Section 4.55(1A) Modification 2 to Affordable Housing Development, Mowbray Road, Lane Cove North

State Significant Development - Section 4.55(1A) Modification Assessment (SSD-71687208-MOD-2)
July 2026

Figure 1 | Height plane diagram showing area which exceed the building height (base source: Applicant's modification report)

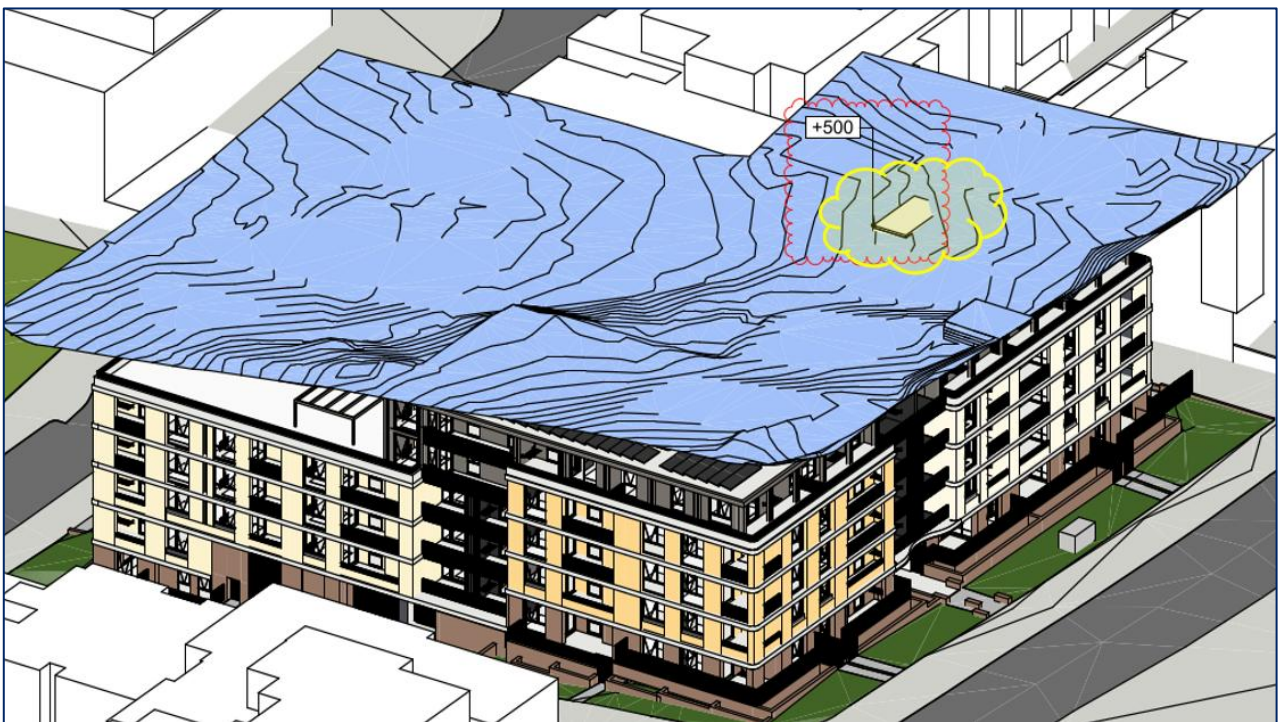
The proposal seeks to increase the building height by 1.58m from 21.67m (RL 66.845m top of lift overrun) to 23.25m (RL 68.445m top of the proposed fire staircase).

The Applicant contends the increase in height is a result of an extension to the fire staircase, to provide access and maintenance of the rooftop.

The proposal would result in a 500 mm (2%) variation to the maximum permissible building height as shown in Figure 1 and 2.

The Department has carefully considered the proposal and is satisfied the increase in building height is acceptable as:

- it would ensure appropriate access to the rooftop to undertake essential maintenance to rooftop plant and equipment
- it is considered minor in the context of the scale of the building, and would not result in adverse visual or overshadowing impacts
- the fire staircase is centrally located within the rooftop and would not be visually noticeable from the public domain or surrounding area.

The Department recommends amending Condition B14 to reflect the revised building height to the top of the fire staircase.
